NFPA STANDARDS DEVELOPMENT SITE SECOND DRAFT REPORT

NFPA 82®, Standard on Incinerators and Waste and Linen Handling Systems and Equipment, 2009 Edition

Figure A.6.3(e) Fire Damper Engineering Alternative for Penetration of Fire-Rated Enclosure.

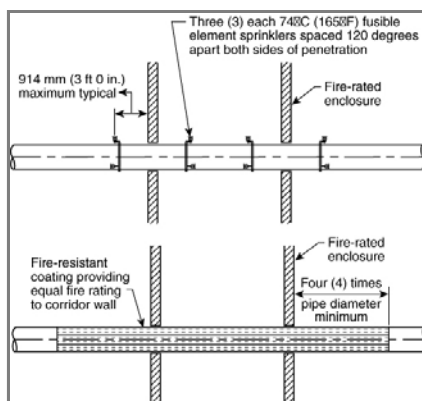
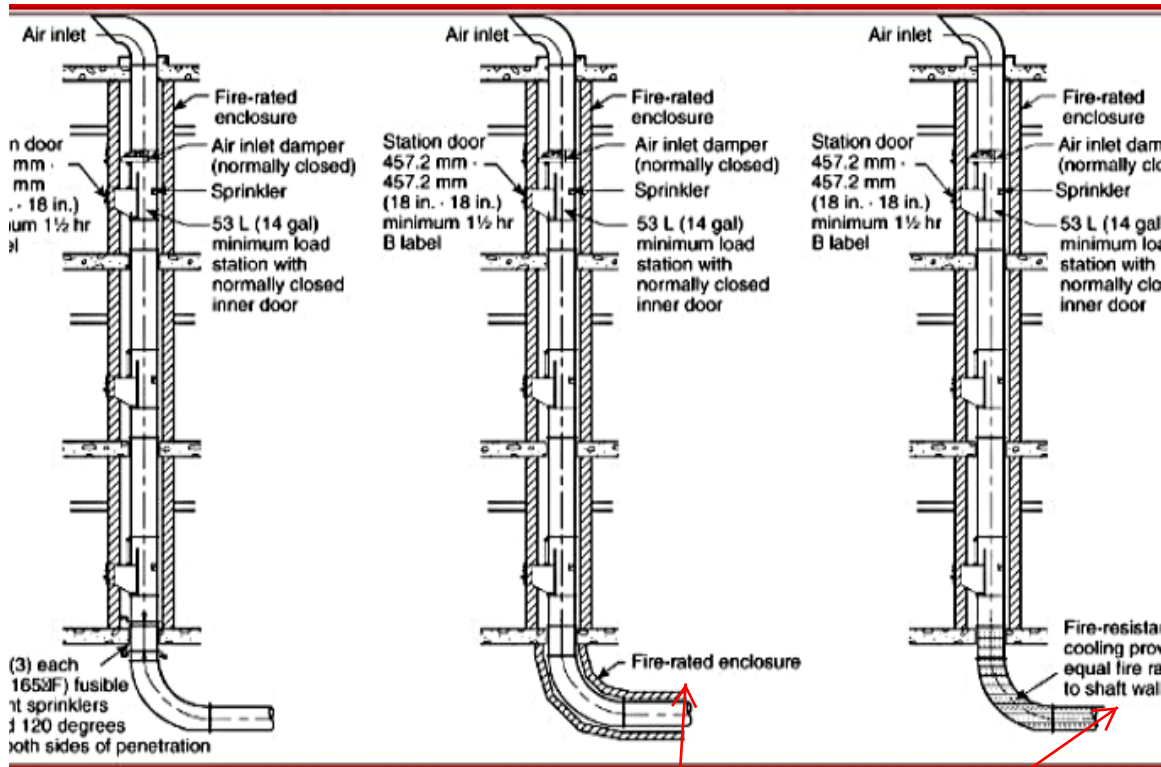
Figure A.6.3 (c) does not indicate how far to extend the fire rated enclosure or coaming past the shaft base pipe exit. I would like to suggest that a distance of 4 pipe diameters be indicated - similar to the requirement for fire wall penetrations indicated in Figure A.6.3 (g). This will eliminate ambiguity and assure that fire safety is not compromised.

Add:
 "Four (4) times pipe diameter, minimum,
 from base of rated shaft"

Committee Action: Rejected

Resolution: The conditions in this scenario are different than those in figure A.6.3(g) and without a proper study the distance might not be appropriate.
